Section 4:  
Distribution List  
And  
Communication Inventory

**Re: Oldcastle Stormwater Master Plan  
Class Environmental Assessment  
Notice of Intent & Invitation to Comment**

# OLDCASTLE STORMWATER MASTER PLAN

**Exhibit A**  
**TOWN OF WINDSOR**  
**COMMENTS.**

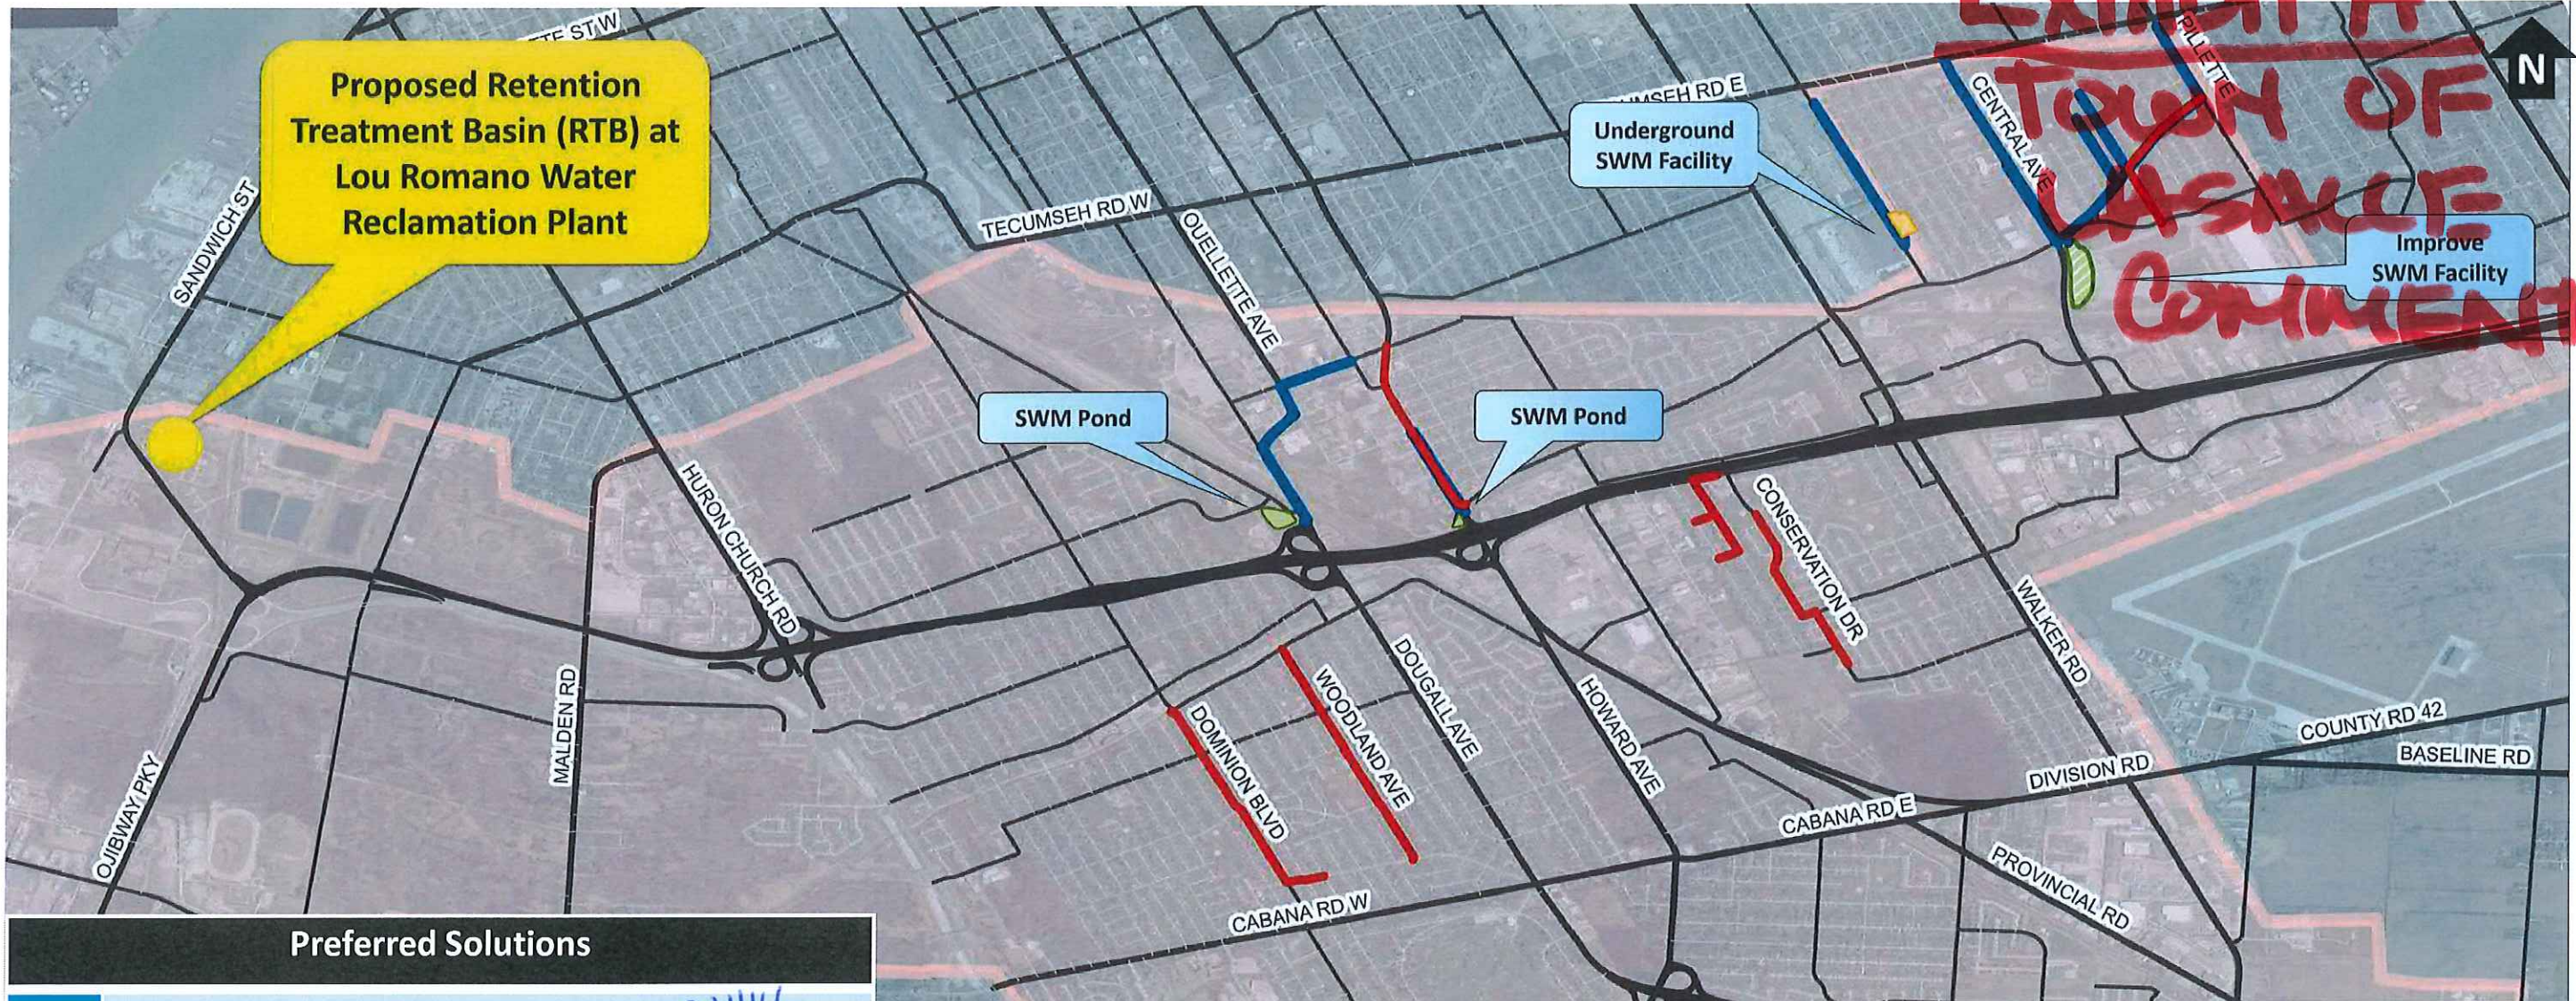
Preferred Solutions	
Source Control	<ul style="list-style-type: none"> <li>Foundation drain disconnection. <i>CATCH DRAIN</i></li> <li>Mandatory downspout disconnection.</li> <li>Seal and repair of the sanitary sewer system.</li> </ul>
Improve Sewer System	<ul style="list-style-type: none"> <li>New storm and sanitary sewers to improve conveyance and storage capacity.</li> <li>New or improved stormwater management ponds or underground storage facilities.</li> <li>Low impact development measures as part of storm sewer improvements.</li> </ul>
Improve Outlet	<ul style="list-style-type: none"> <li>Retention Treatment Basin (RTB) at Lou Romano Water Reclamation Plant.</li> </ul>

Title <b>WOLFE DRAIN 100-YEAR OUTFLOW HYDROGRAPHS</b>	Date JUNE 2021	<b>FIGURE B4</b>
	Scale NTS	
Project <b>OLDCASTLE STORMWATER MASTER PLAN</b>	Project No. 19-010

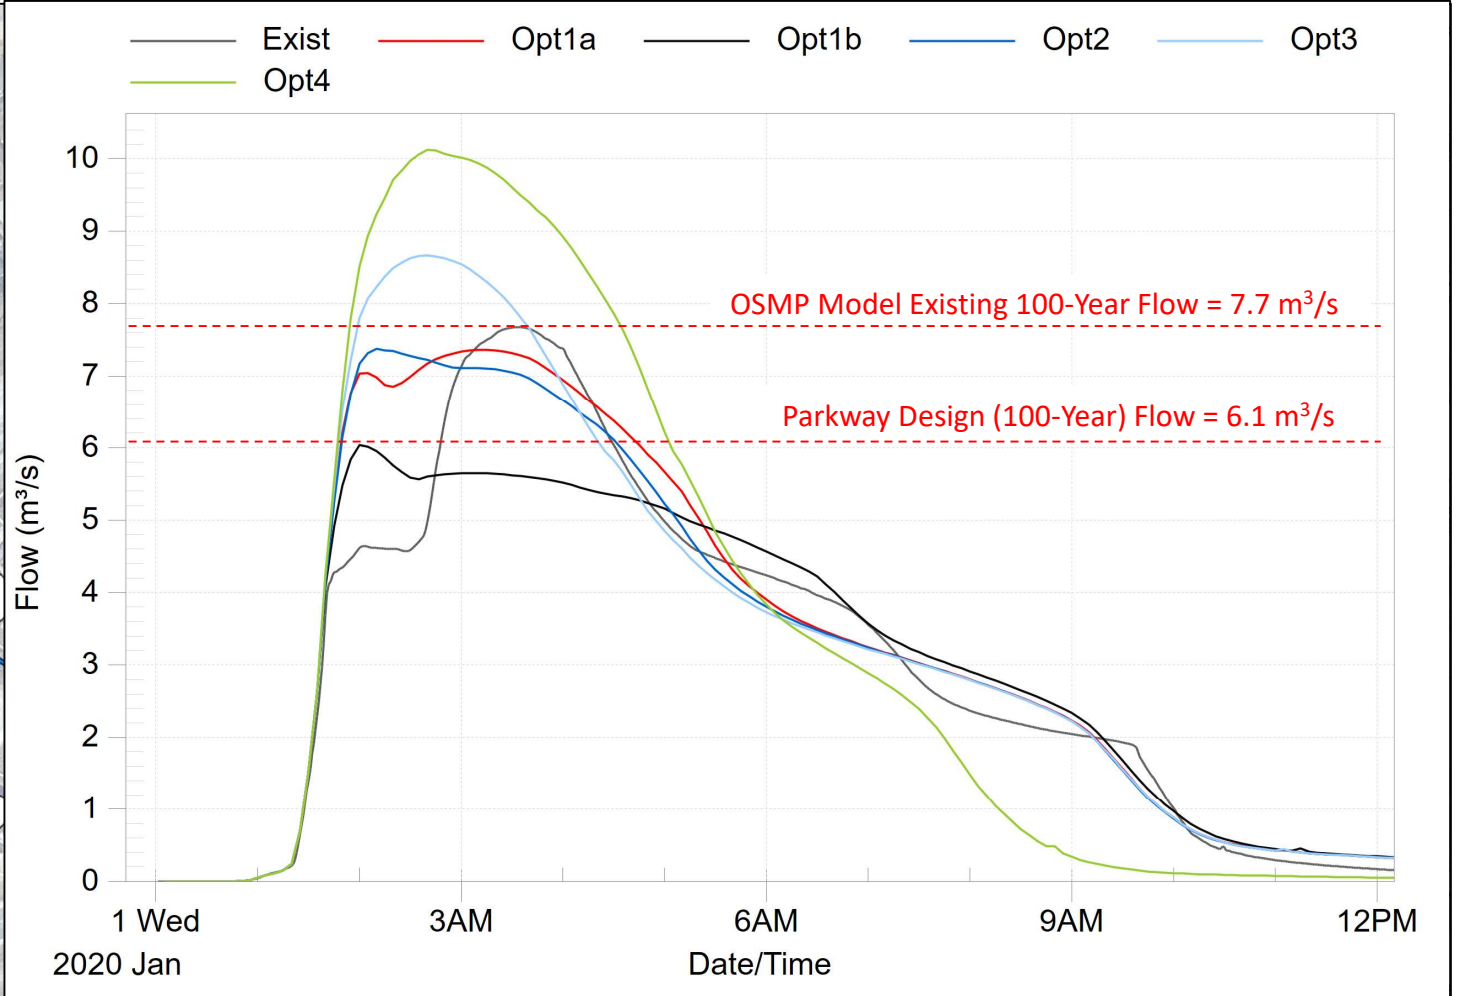
A reduction in the high-water level at the Highway 3 low point of as much as 0.35m could be achieved with the implementation of either Option 1a or Option 2 – both of which result in a flow of approximately 7.4 m<sup>3</sup>/s, which less than the existing flow rate of 7.7 m<sup>3</sup>/s (see Figure B4 for flow hydrographs).

Also shown in Figure B4 are flow hydrographs for Options 3 and 4. Again, these two options would only be valid if the findings of the ongoing *Turkey Creek Study* determine that the downstream receivers can safely convey these peak flows. As shown in Figure B3, the high-water levels associated with Options 3 and 4 are similar to Option 1B at the key area of concern (i.e., low point of Highway 3, adjacent to new Collins Drain Pond).

# Michael Tool & Mold 2340 Olympia Drive

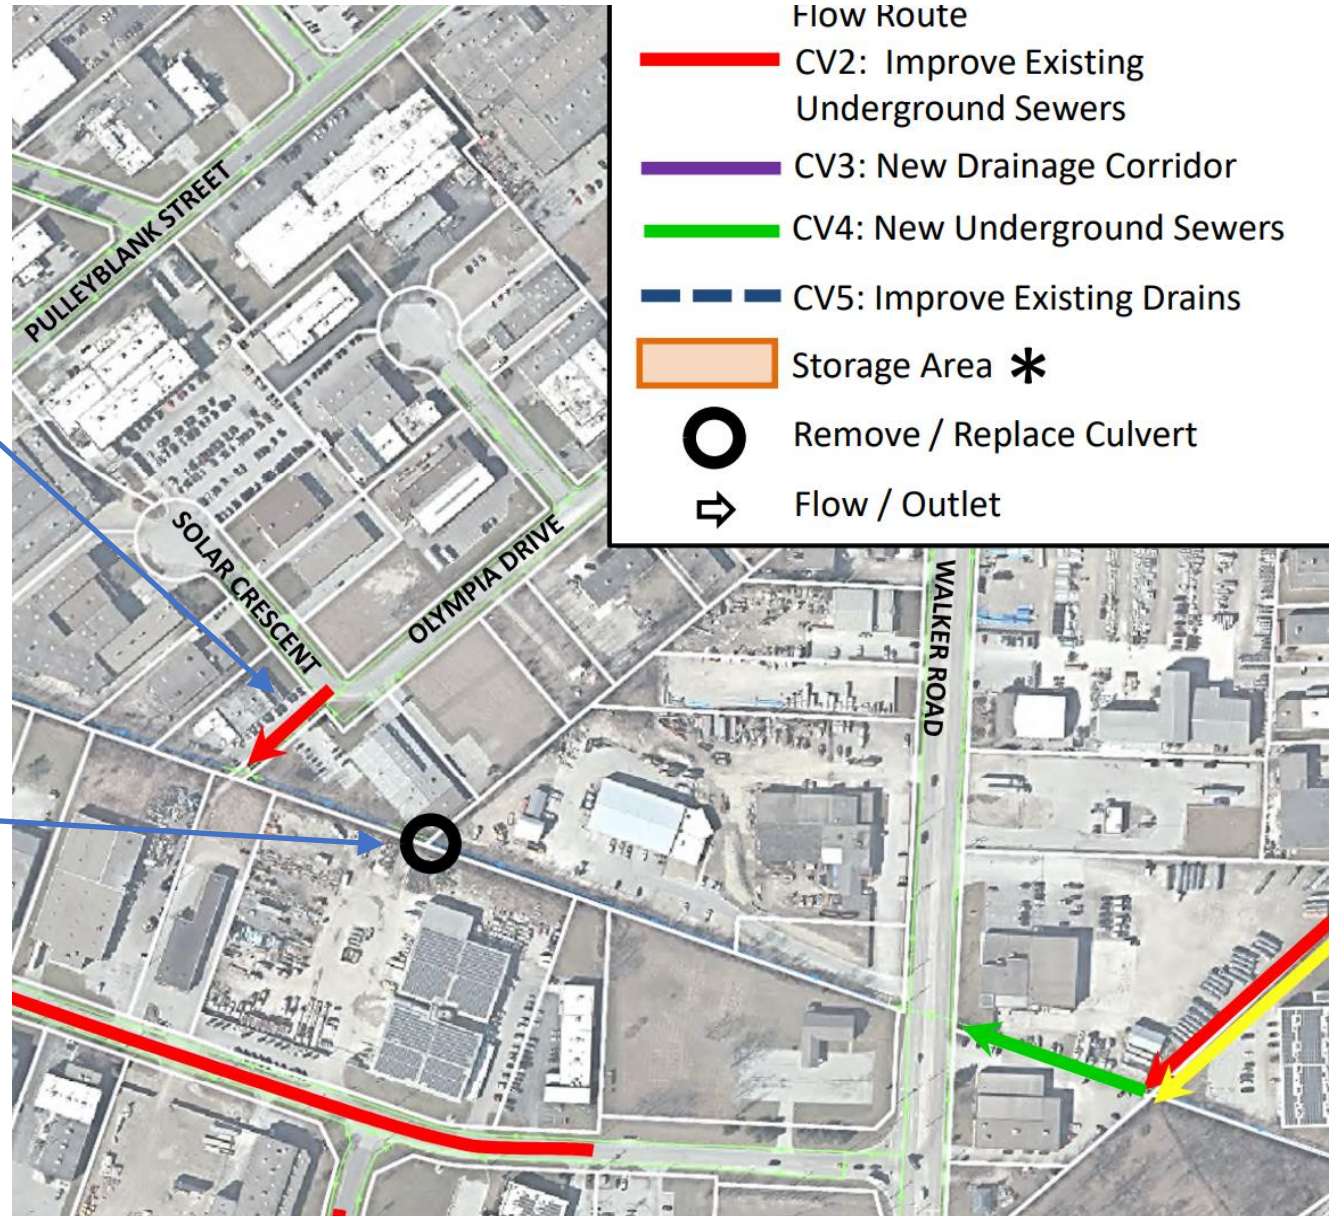
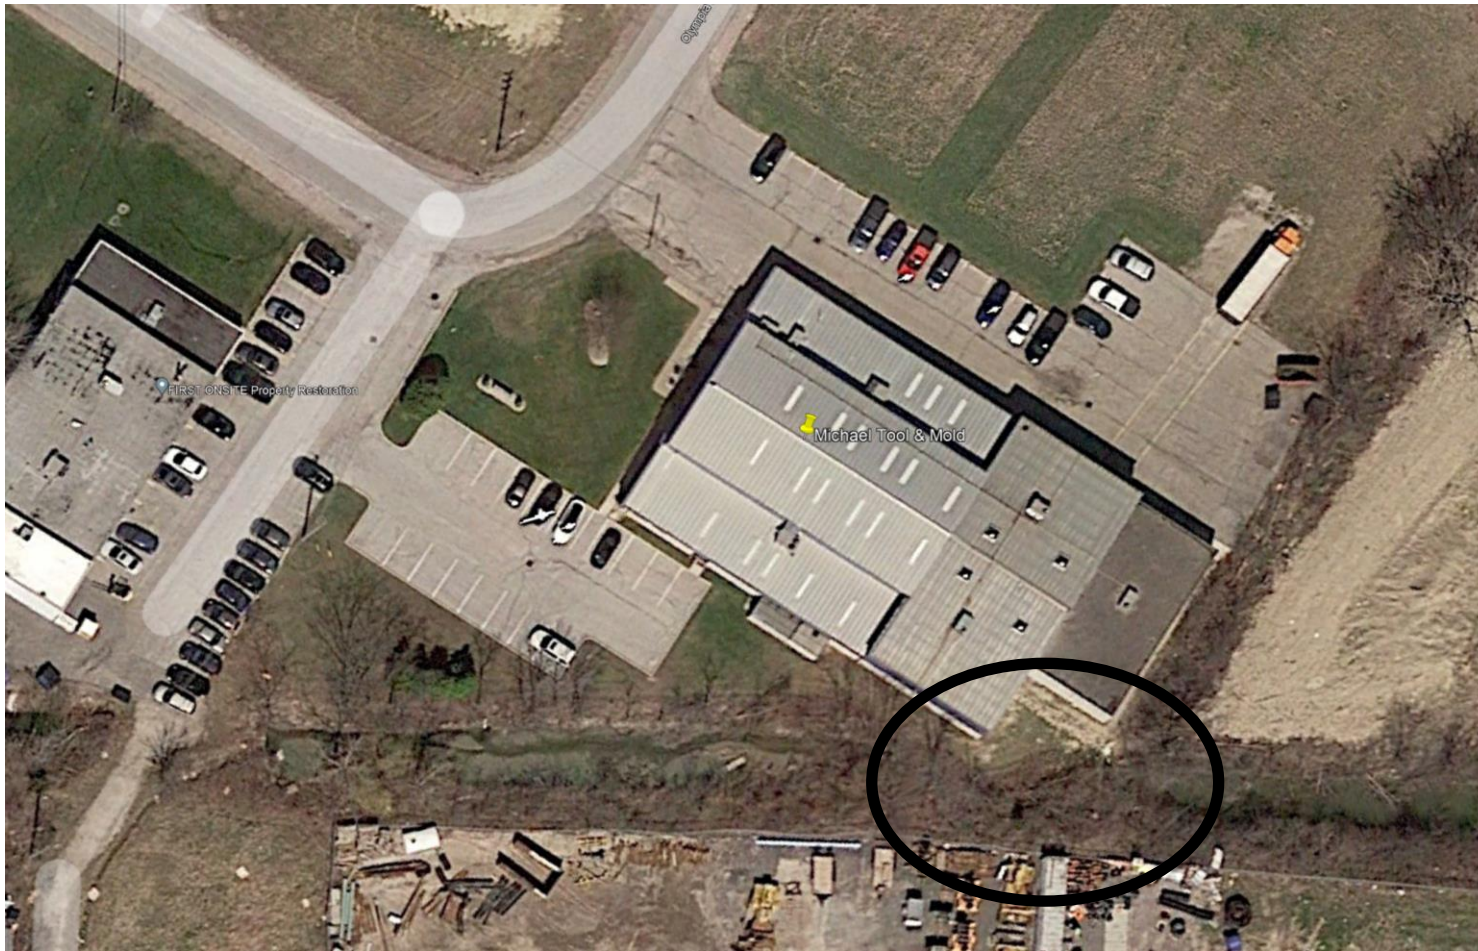
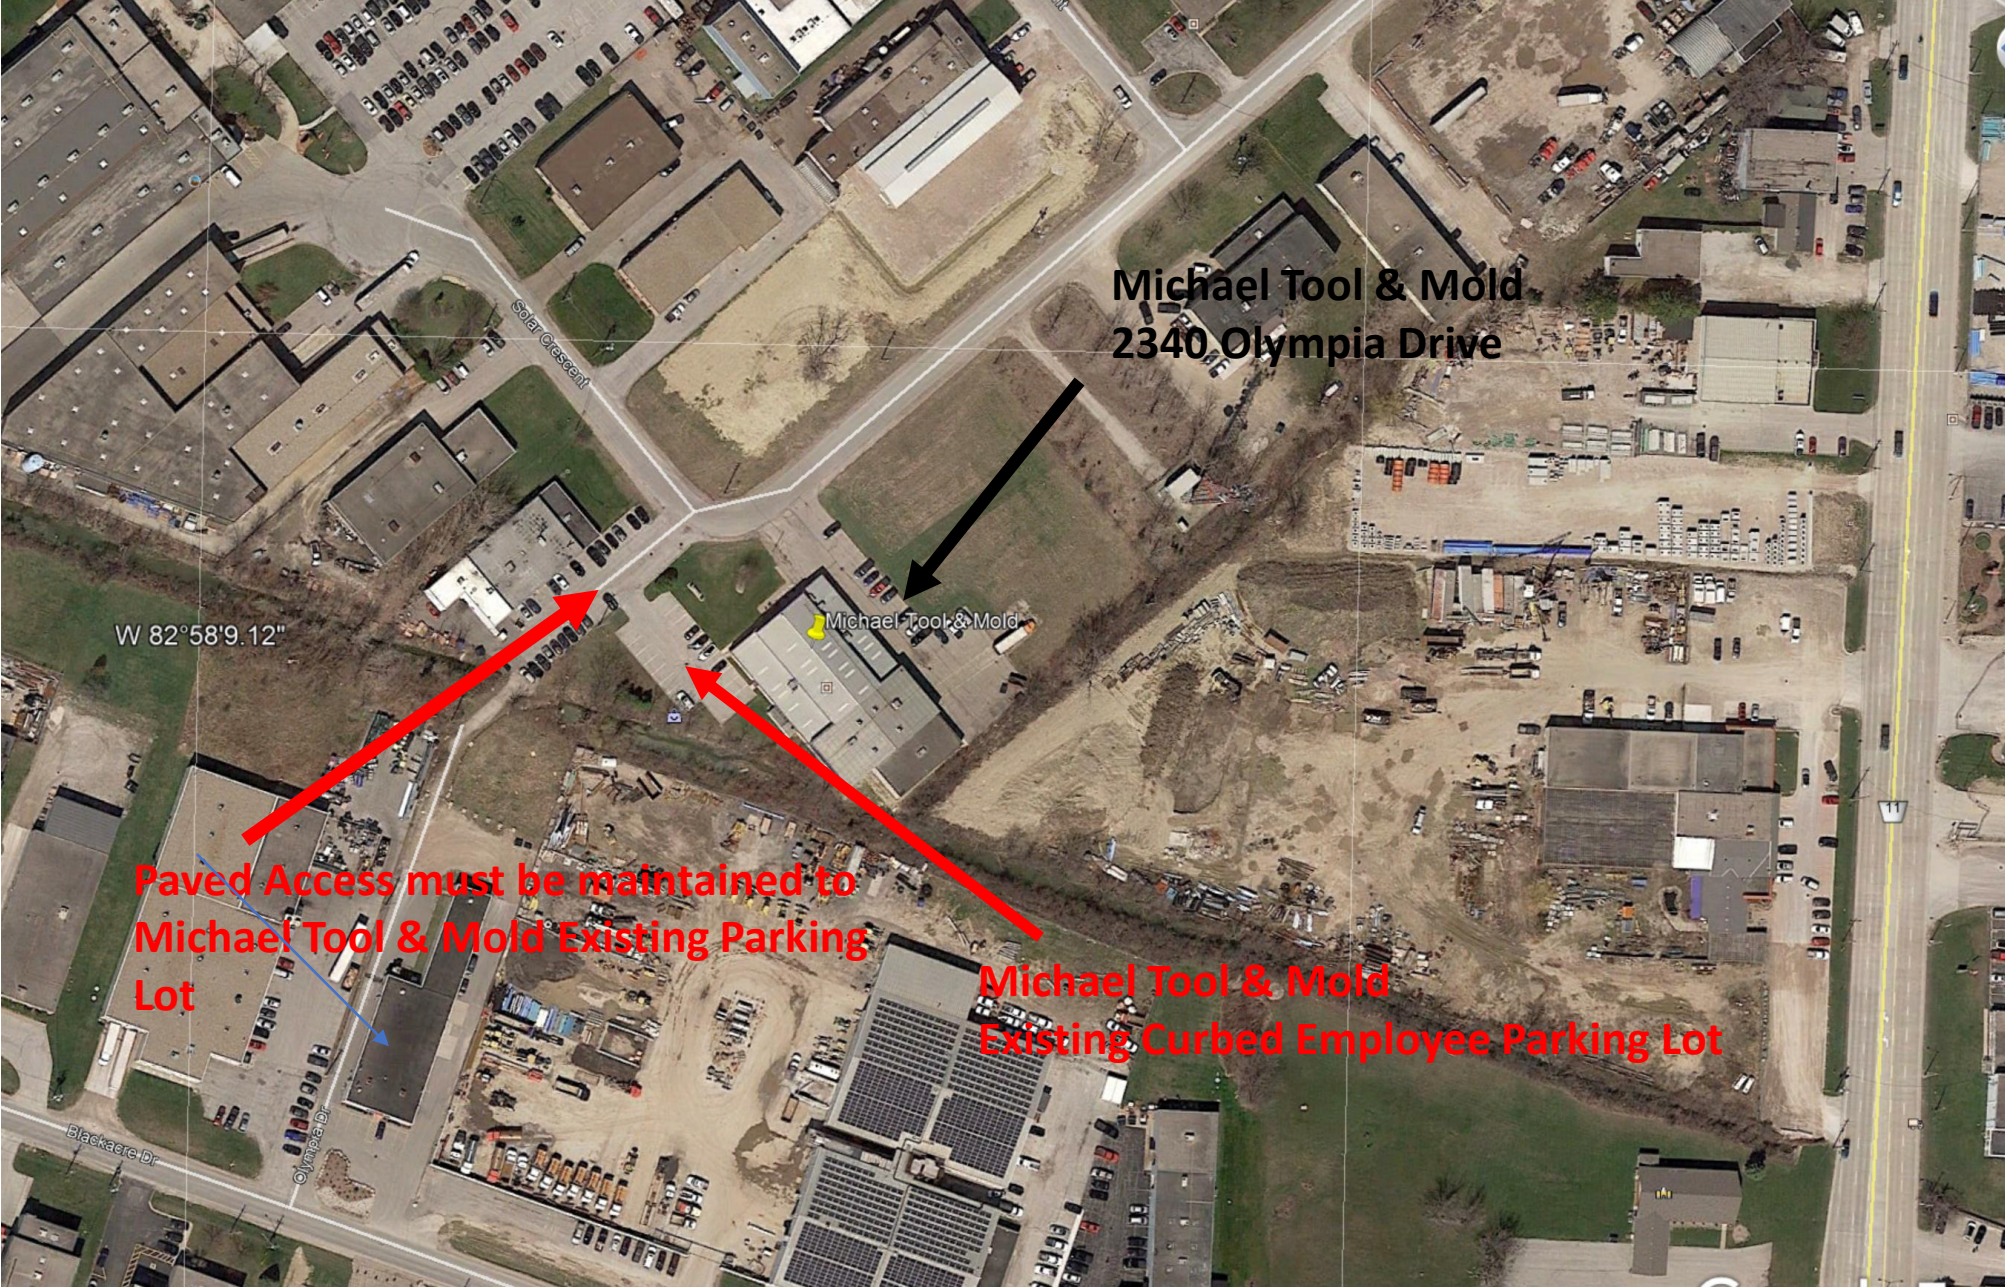
Please advise how the "Remove/Replace Culvert" will be implemented?

From which property will access be required in order to complete work?  
(Michael Tool? Amico? DBI/Elmara?)

In regards to culvert “remove/replace”, the area between corner of building and existing drainage ditch is very narrow / limited. How will work be completed?
